Appendix 2.3: Stephenson Halliday response to NatureScot in relation to Merrick Wild Land Area

Craiginmoddie Wind Farm
ECU00002196

Clarifications for NatureScot – Merrick Wild Land Area

FIGURE 1

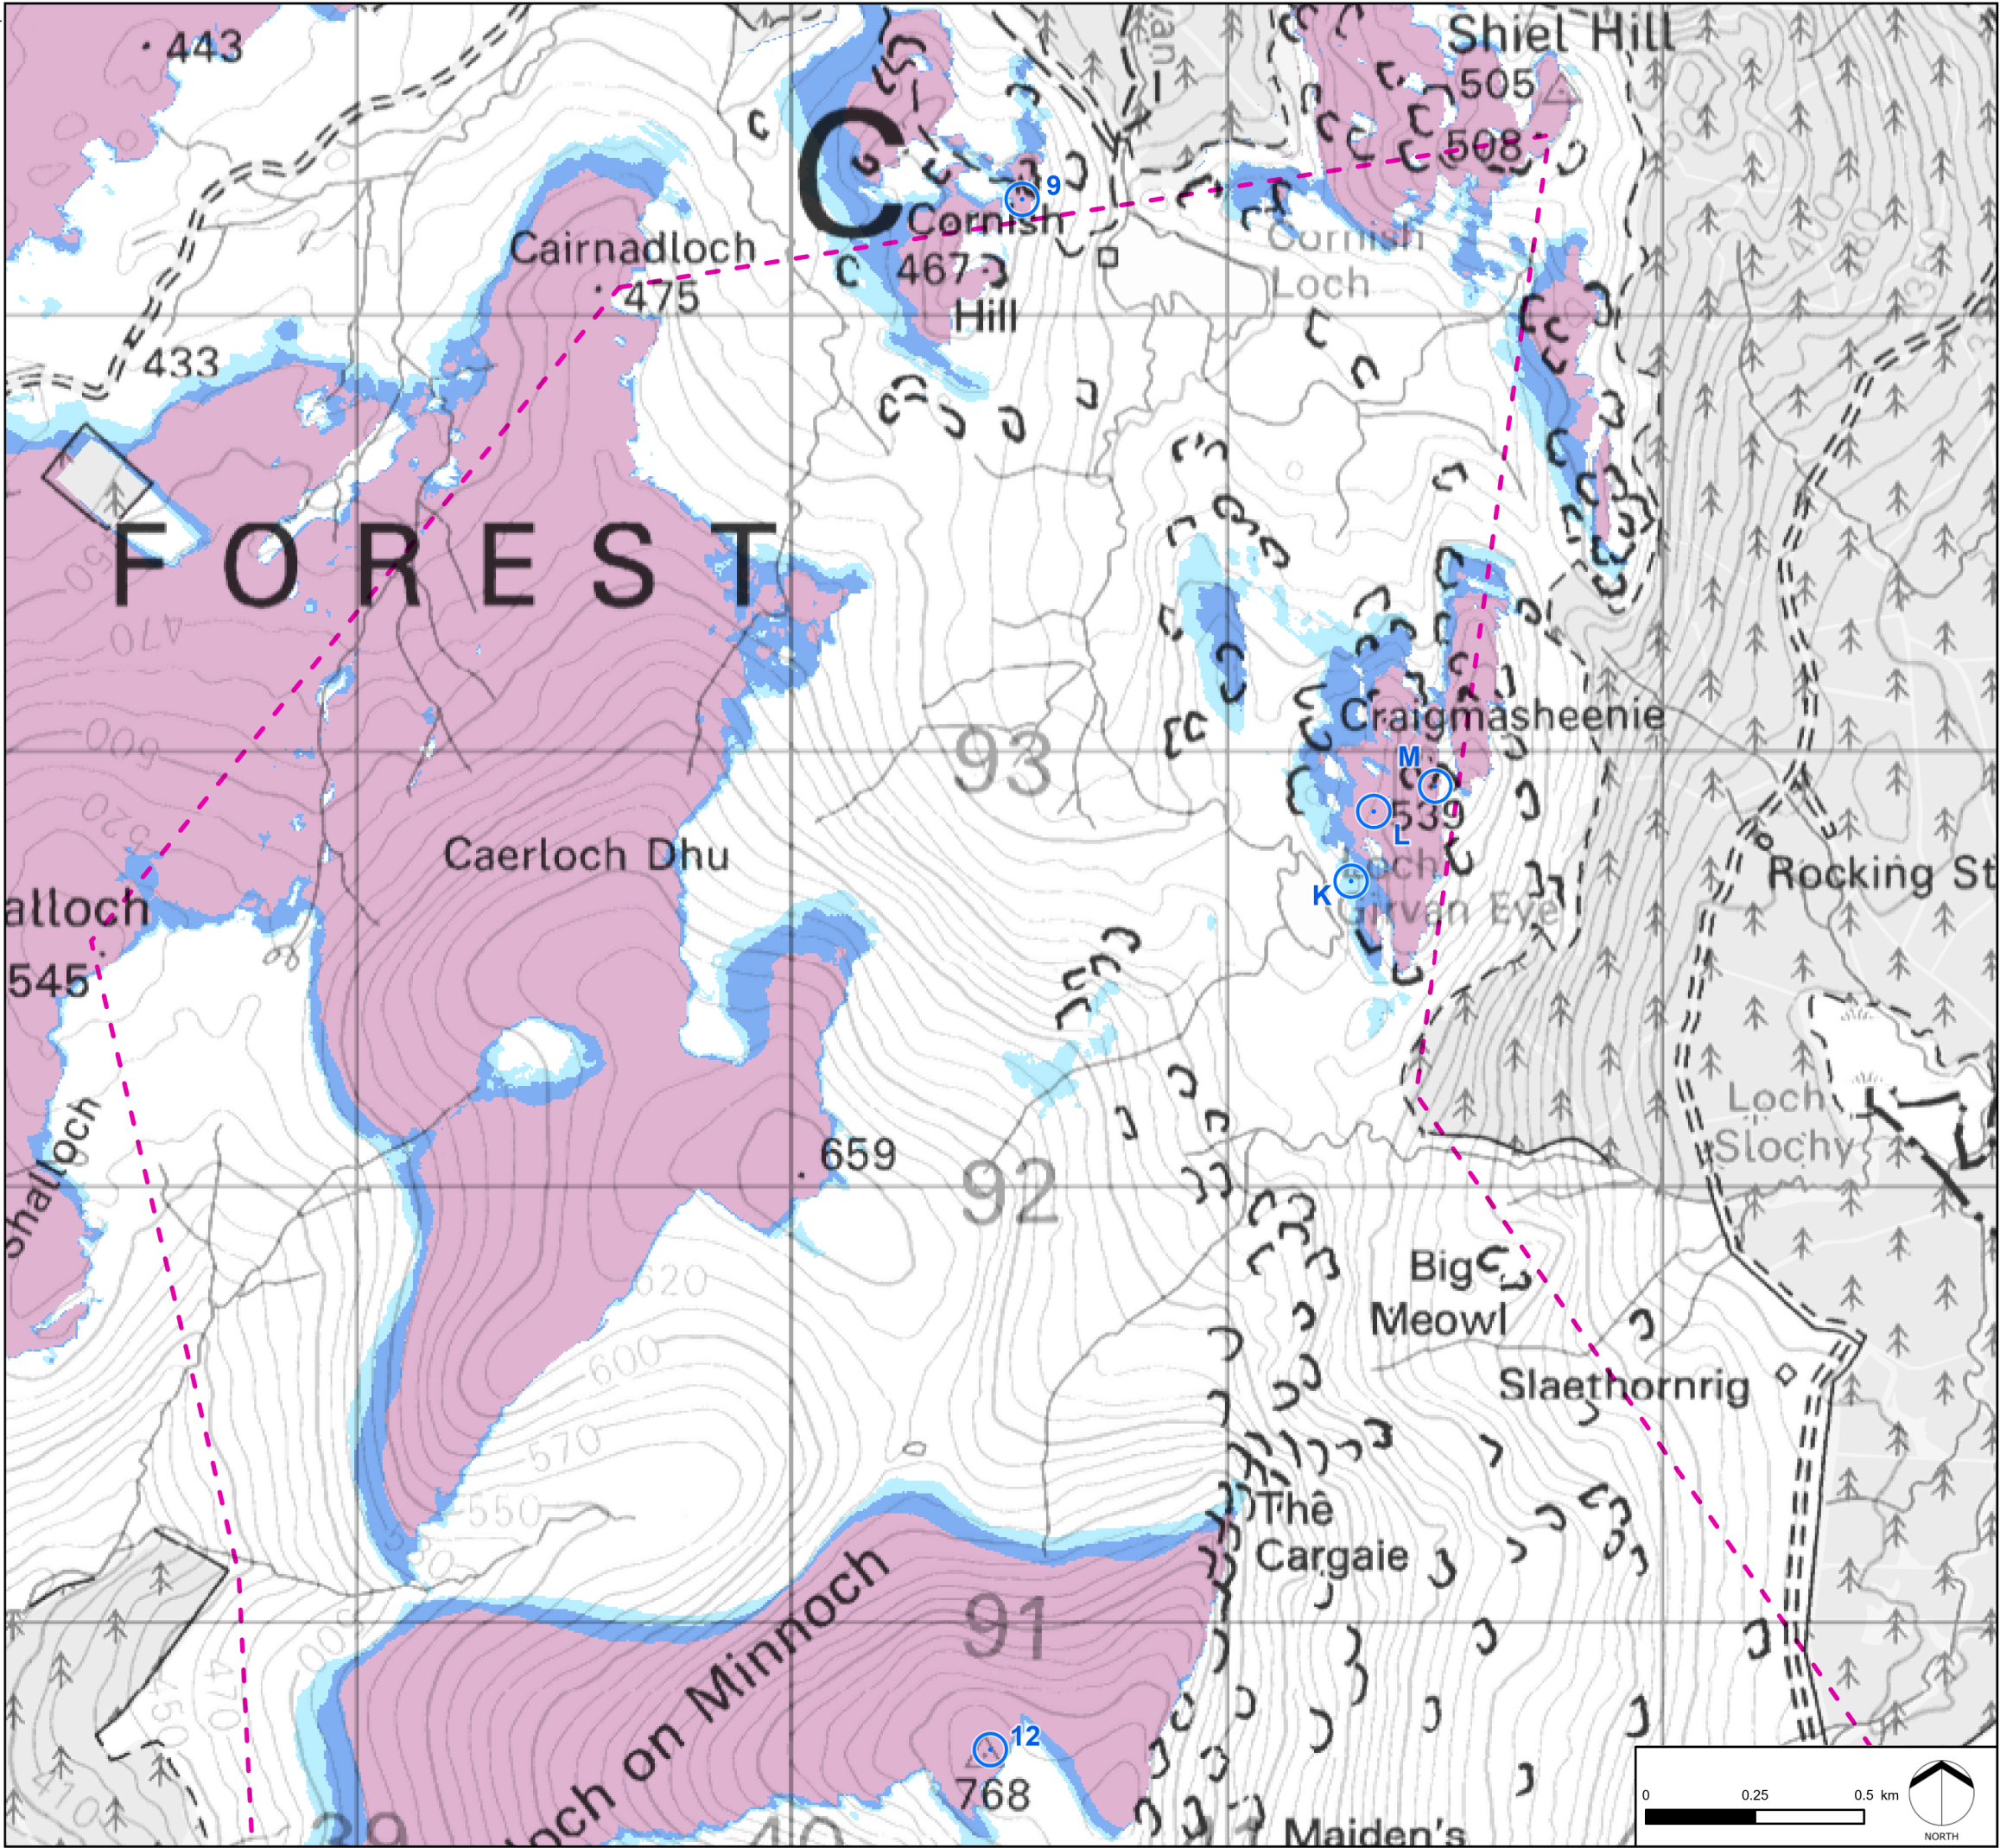
- *a wireline from the area around Loch Girvan Eye in the far north east of the WLA –.*
- *we are looking for viewpoint location between Craigmasheen and Loch Girvan Eye and also indicating relevant operational and consented developments.*

“We believe that this is an area of high relative wildness where it seems, under closer examination of the ZTVs, that a number of turbine hubs might be visible and the existing wild land assessment produced to date does not provide suitable detail for our assessment purposes.

This detail is needed to clarify an issue with visibility in the far north east of the WLA which we believe is an important consideration in this application.”

A hub height aviation lighting ZTV was included as Figure 6.12 within the EIA Report and illustrates potential visibility across the Merrick WLA. In order to assist NatureScot’s assessment of the proposals, Figure 1 has been prepared which illustrates an enlarged section of the hub height aviation lighting ZTV covering just the northern part of the WLA, including Loch Girvan Eye and Craigmasheenie.

The zoomed in area of the ZTV shown illustrates that there would be no visibility of turbine hubs or aviation lighting from Loch Girvan Eye itself although a small number would become visible within approximately 10–30m from the eastern edge. Visibility of turbine hubs and lights would then gradually increase moving northeast up the western side of Craigmasheenie.
